PD Modification Application: PRS 25-0573**Zoning Hearing Master Date:** N/A**BOCC Land Use Meeting Date:** June 10, 2025**Hillsborough
County Florida****Development Services Department****1.0 APPLICATION SUMMARY****Applicant:** Epg1 LLC Epg Berry Bay Holdings LLC**FLU Category:** WVR-2 (current)
RES-4 (pending)**Service Area:** Rural (current)
Urban (pending)**Site Acreage:** 53.43 +/-**Community
Plan Area:** Wimauma**Overlay:** None**Introduction Summary:**

The subject site is Planned Development (PD) 24-0044. PD 24-0044 covers two non-contiguous development areas with transferred density from one area (Bullfrog Creek Mitigation Area) to the other area (Berry Bay Receiving Area). The PD is approved for 1,157 residential units and a public use facility. When originally rezoned, the site was within the WVR-2 Future Land Use Category and the Rural Service Area, which necessitated compliance with WVR-2 Residential development standards. Subsequently, two Comprehensive Plan Amendments (CPA 24-44 and CPA 24-45) have been approved by the BOCC which will place the PD within the RES-4 Future Land Use Category and within the Urban Service Area. Therefore, this makes the WVR-2 Residential r

8.2 Proposed Site Plan (Full)

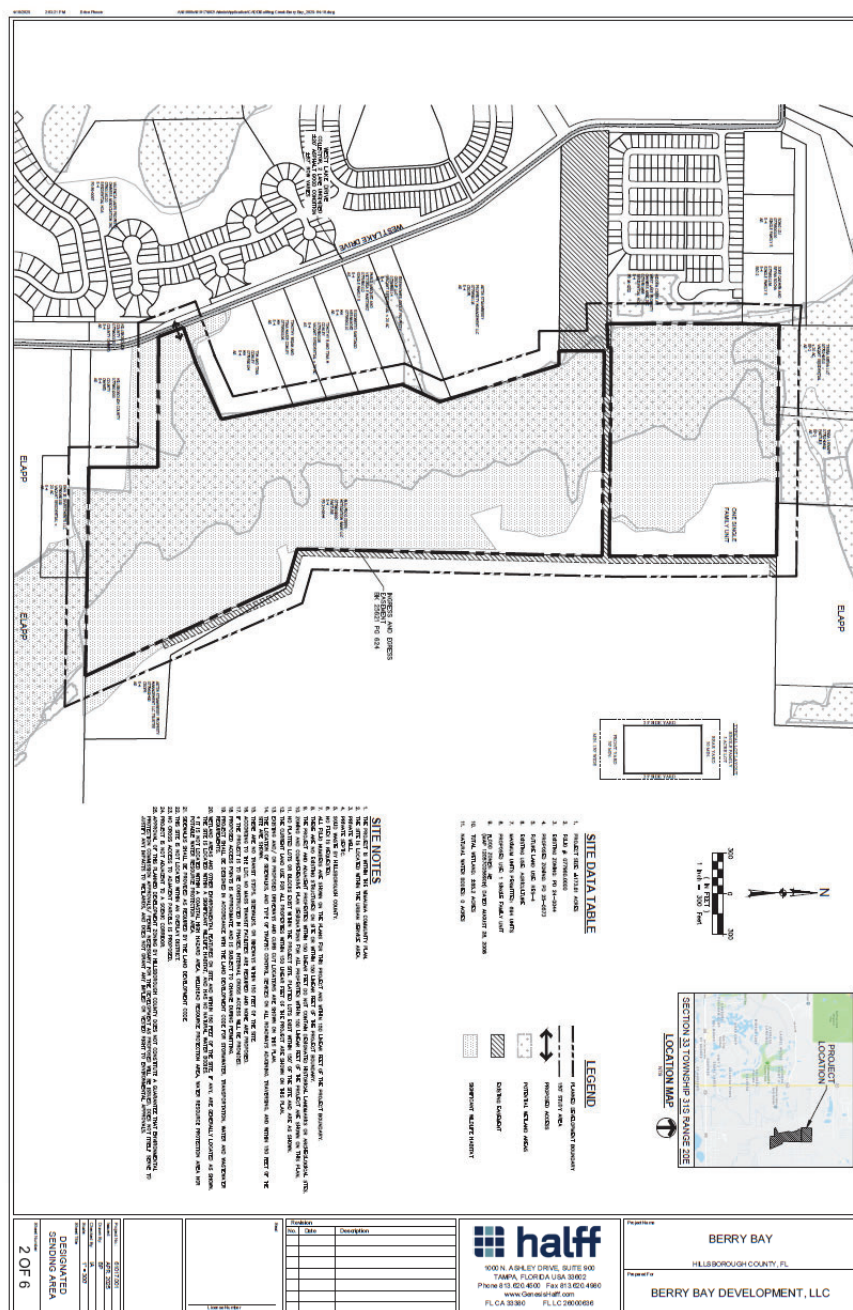
The applicant is requesting a minor modification, also known as a Personal Appearance (PRS) to a +/- 55-acre portion of a currently zoned Planned Development (PD) 24-0044, identified as Pod O on the PD site plan. The existing PD is approved with entitlements of the modification area which permit 78 single-family detached units within Pod O. The applicant is proposing to remove the Wimauma Village Residential development standards for Pod O with the removal of existing condition no 3.

With this request the applicant is not proposing any changes to access connections. The existing connections to Pod O are through Pod D and Pod F to Berry Grove Blvd and an additional access connection to Bonita Dr. The developer is not requesting to change the requirement to provide a stub out to the east of Pod O for future a pedestrian and vehicular connection.
